ADDENDUM # 4

BID NO. : 2272
OPENING: 11/21/2012 3:00 PM
COMMODITY: URI Residence Hall Basketball and Volleyball Courts

NOTICE OF ADDENDUM NO. 4

The Rhode Island
Board of Governors for Higher Education
University of Rhode Island and State of Rhode Island
Public Bid No. 2272
URI Residence Hall Basketball & Volleyball Courts
Kingston, Rhode Island

DRAWING TITLE
DETAILS 1

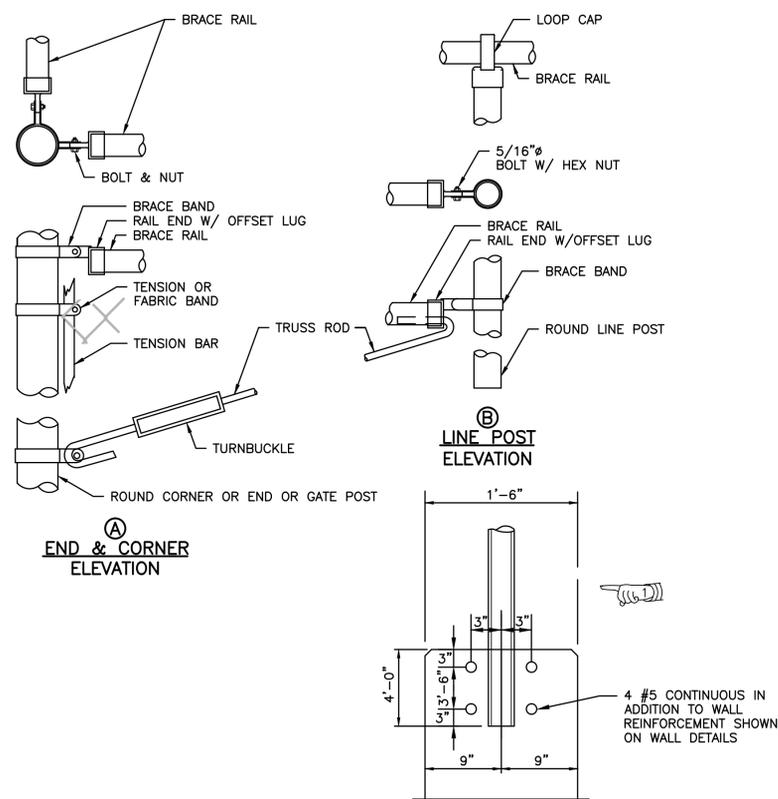
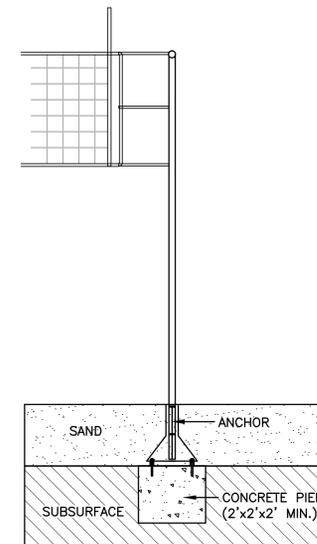
3.2.3 The wall design shall include a fence post wind load of 23 plf x the post spacing applied horizontally at a height of 6'-8" from the base of the fence or top of the wall. The fence post spacing shall not be less than 7'-8" nor more than 11'-6".

3.2.3 The wall design shall include a fence post wind load of **166** plf x the post spacing applied horizontally at a height of 6'-8" from the base of the fence or top of the wall. The fence post spacing shall not be less than 7'-8" nor more than 11'-6".

- 1. Delete the plans listed below and replace with the attached, Addendum No. 4

<u>Dwg. No.</u>	<u>Drawing Title</u>	<u>Date</u>
5	Details No. 1	June 2012
